Access Compliance Report

Public Rights-of-Way

(Curb Ramps)

Intersection ID: 19953	Main Street: ARCHDALE_DR	Cross Street: OLD_PINEVILLE_RD	Location: SW
ADA ID: D972566C9BF4	Ramp Type: Perp	Initial Pass/Fail: Fail	Overall Compliance: No
Codes/Mitigation Info/Possible Solution		Field Measurements/Component Compliance	
Severity Score: 21.25

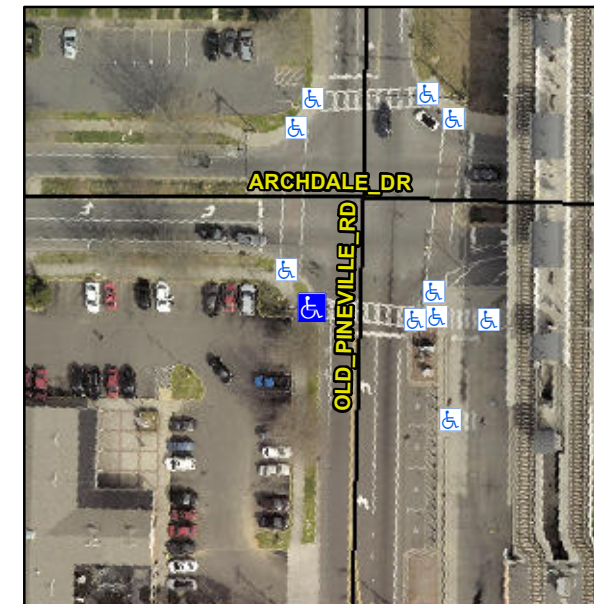
R304.5.1, R304.2.2

Compliance	Description	Data	Compliance	Description	Data
N/A	Ramp Length (in)	72.0	No	Ramp Slope (%)	10.2
No	Ramp Width (in)	46.5	Yes	Ramp XSlope (%)	1.6
N/A	Flare Type LT	N/A	N/A	Flare Type RT	N/A
N/A	Flare Slope LT (%)	N/A	N/A	Flare Slope RT (%)	N/A
N/A	Flare Traversable LT?	N/A	N/A	Flare Traversable RT?	N/A
N/A	Landing Length (in)	N/A	N/A	DWS Provided?	N/A
N/A	Landing Width (in)	N/A	N/A	DWS Contrast?	N/A
N/A	Landing Slope (%)	N/A	N/A	DWS Length (in)	N/A
N/A	Landing X Slope (%)	N/A	N/A	DWS Full Width?	N/A
N/A	Landing Curb? (Y/N)	N/A	N/A	DWS Offset (in)	N/A
N/A	Shared Landing?	N/A			
N/A	Gutter Ponding?	N/A	N/A	Gutter Slope (%)	N/A
N/A	Gutter Lip Ht (in)	N/A	N/A	Gutter X Slope (%)	N/A
N/A	Painted X Walk1?	No	N/A	Painted X Walk2?	N/A
	X Walk 1 Direction	To E		X Walk 2 Direction	N/A
N/A	X Walk 1 Width (in)	N/A	N/A	X Walk 2 Width (in)	N/A
	X Walk 1 Slope (%)	1.7		X Walk 2 Slope (%)	N/A
	X Walk 1 X Slope (%)	2.3		X Walk 2 X Slope (%)	N/A

Remove & Replace Entire Ramp.
